**PLANNING COMMISSION
MEETING AGENDA
REGULAR MEETING**

September 26, 2023

SUBJECT: PUBLIC HEARING - SPECIAL USE APPROVAL AND PRELIMINARY SITE PLAN REVIEW (SU JPLN2023-0019) - Proposed Clean Express Car Wash, West side of John R, North of Fourteen Mile (PIN 88-20-35-401-001), Section 35, Zoned GB (General Business) District

Preliminary Site Plan For City of Troy, Michigan

SCALE: 3/16" = 1'-0"
SHEET # / DESCRIPTION
EXTERIOR ELEVATIONS
DATE: 05.17.2023
PRELIMINARY DESIGN
SBA STUDIOS PROJECT # 2022-407

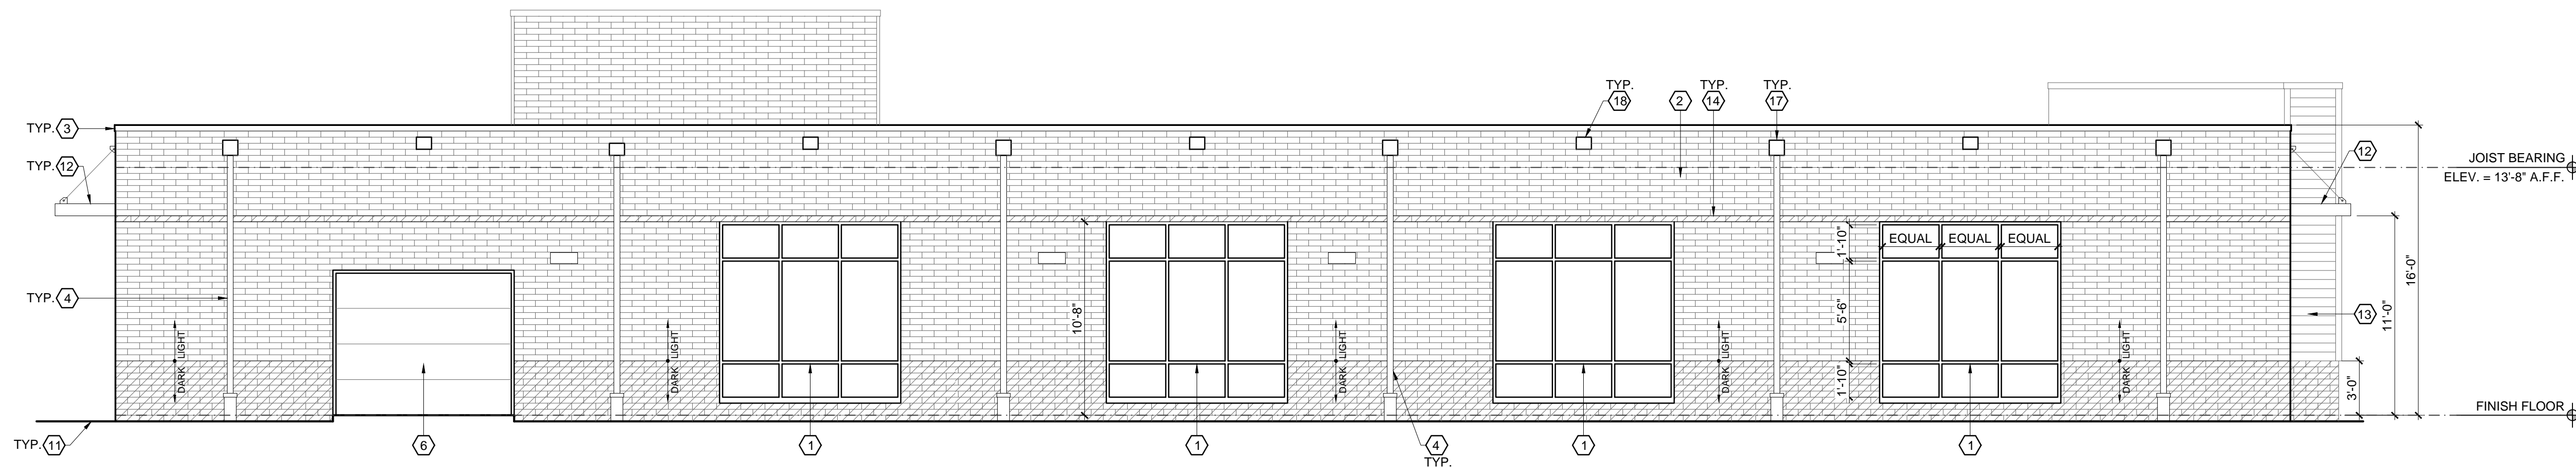
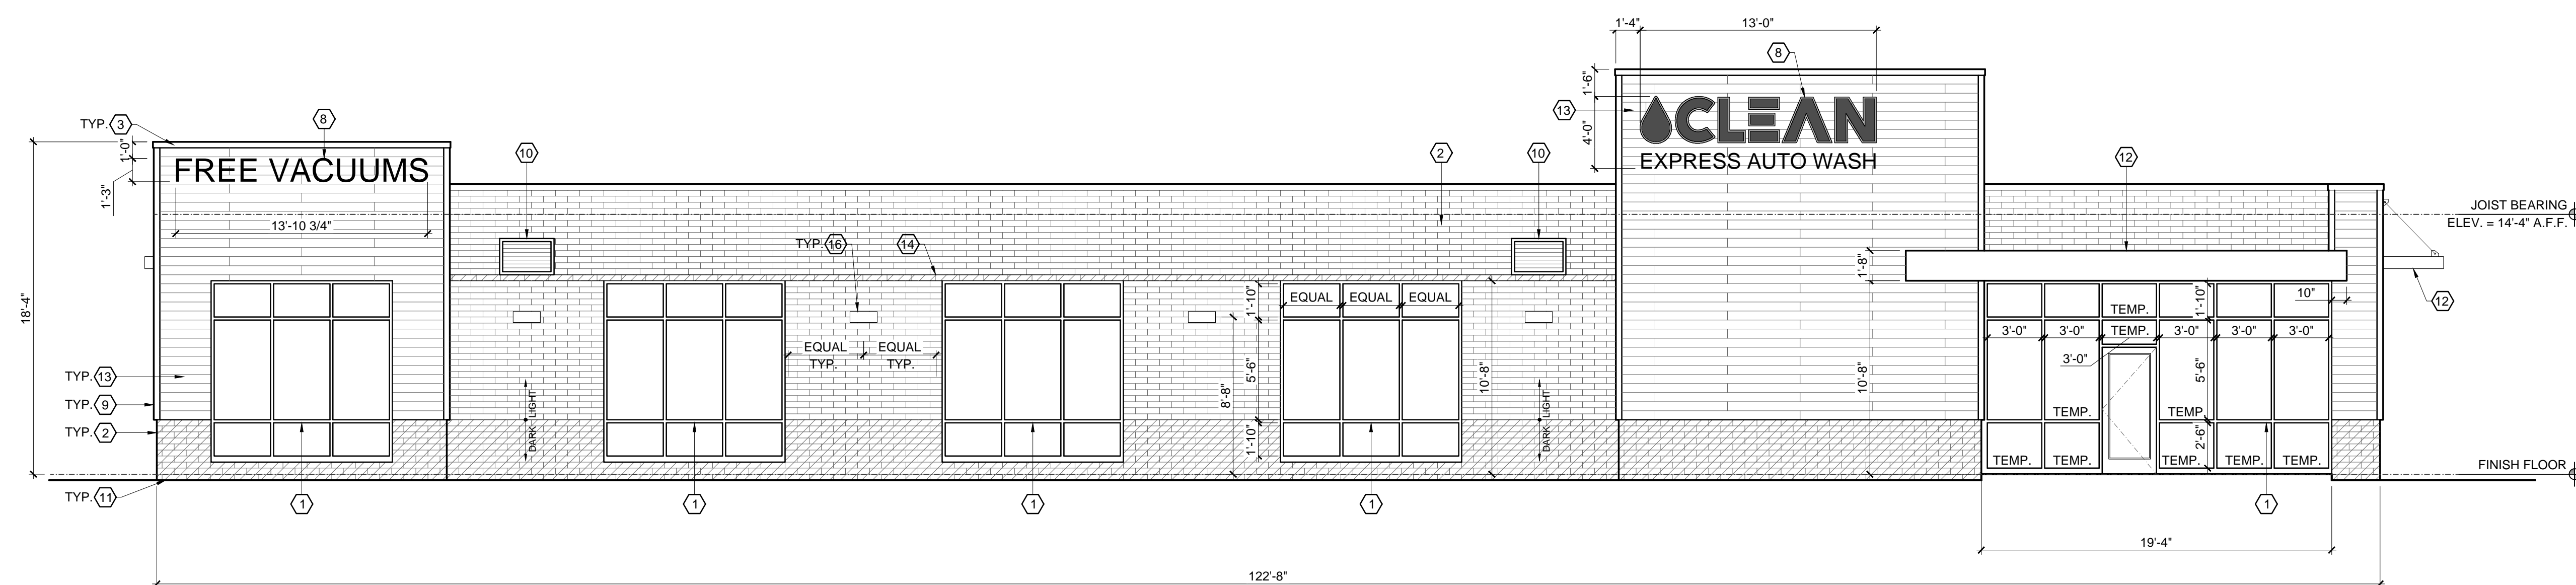
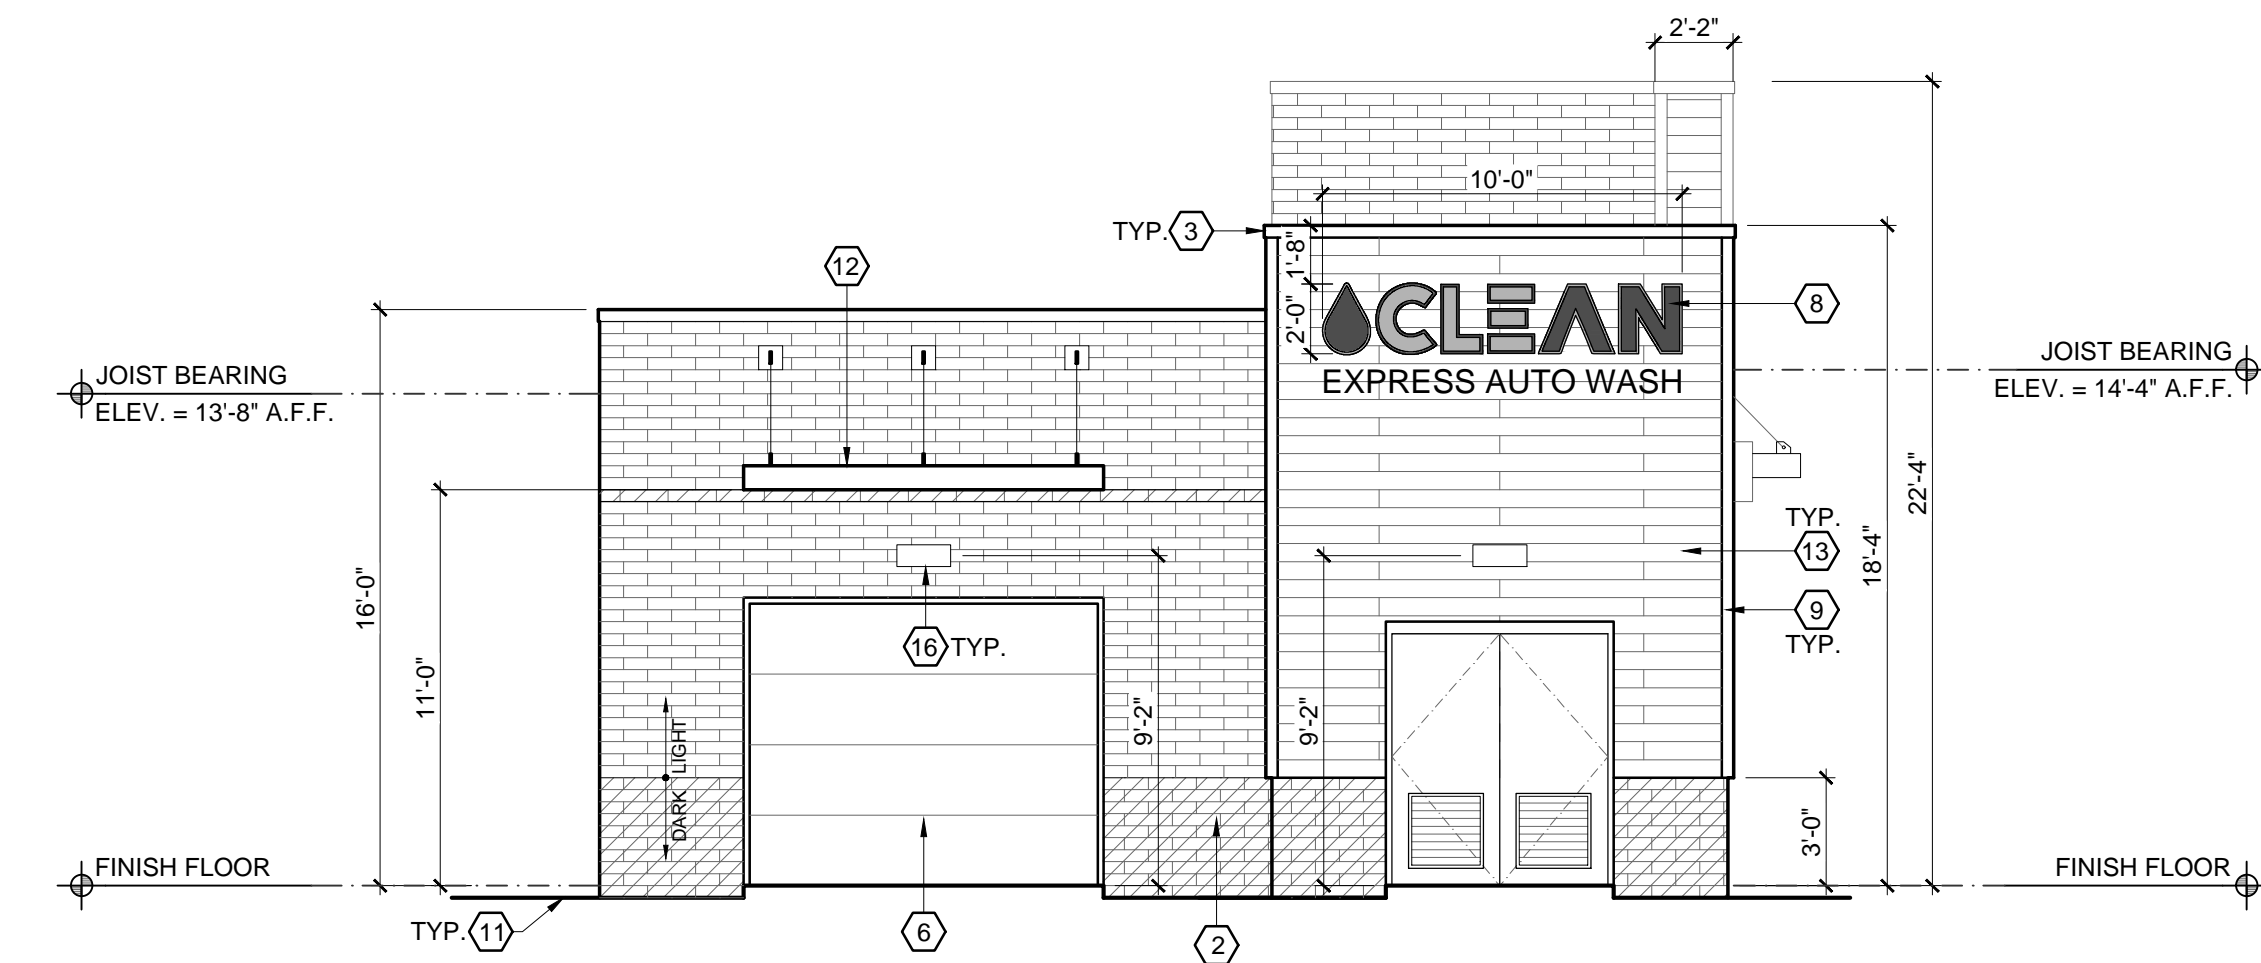
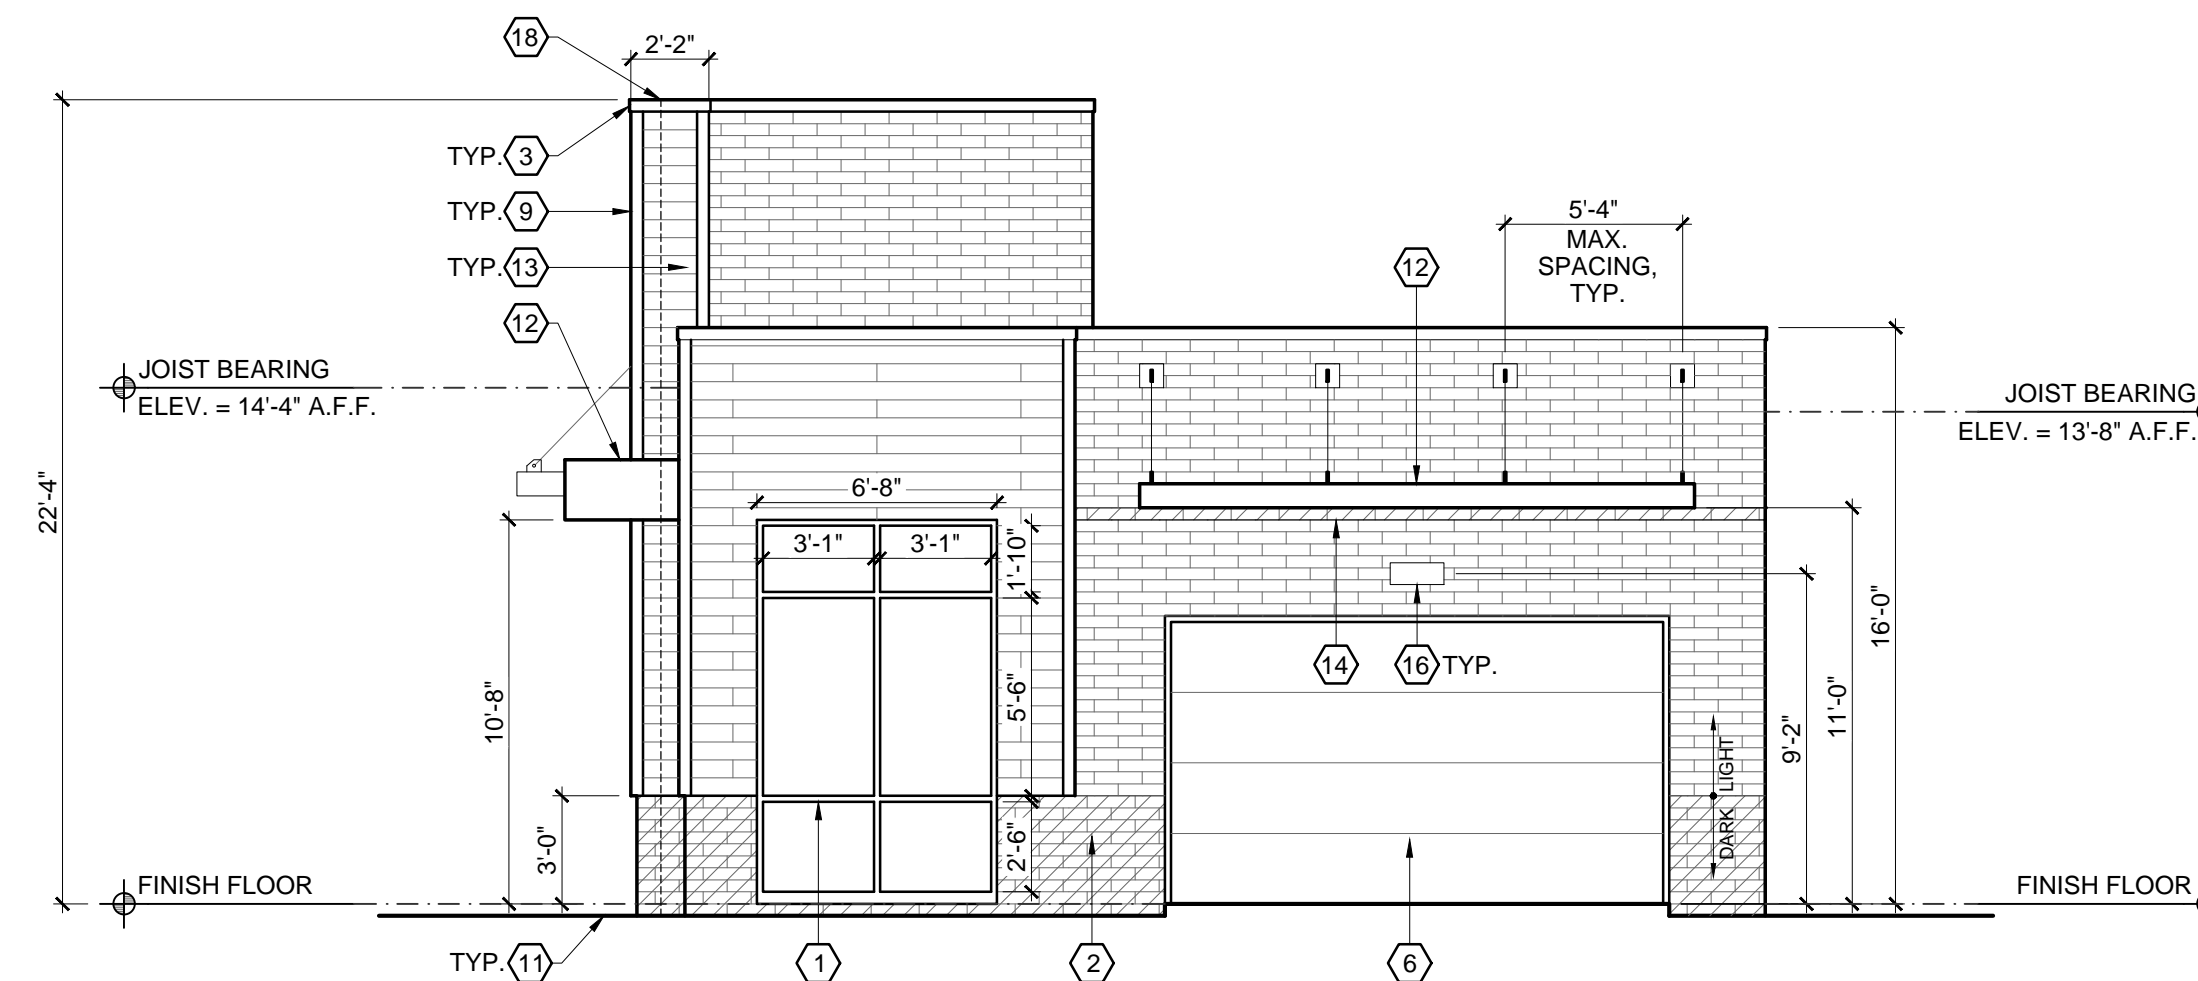
Floor plans and elevations have been provided. The primary material is brick. A rendering shows a color scheme of white brick, natural brick, and green vacuums. The proposed canopy over the pay area is red. The applicant should describe how the color scheme of the canopy matches the color scheme of the building.

The applicant has provided a rendering of a Clean Express carwash, but we note it's not site specific. The applicant should confirm if they propose the general material use and color scheme as shown in the rendering. To better understand architectural details and site context, the applicant should provide a 3-D model of the site in context of the malls buildings and John R.

Items to be Addressed: 1). Applicant should confirm if they propose the general material use and color scheme as shown in the rendering; and 2). Provide site specific 3-D model.

8 BIKE RACK DETAIL, OR EQUAL
NOT TO SCALE

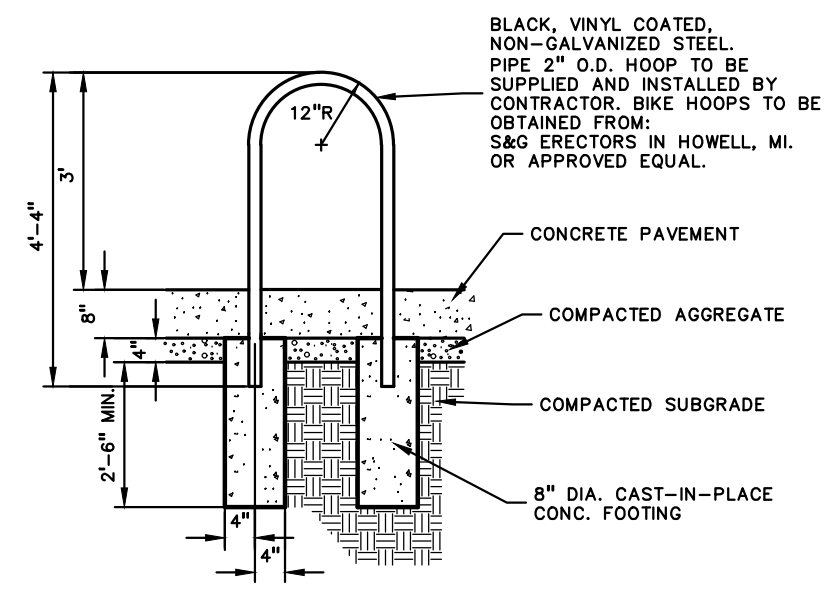
Details for bike racks are provided on sheet L-1.2 however their location is absent from any site plan sheets.
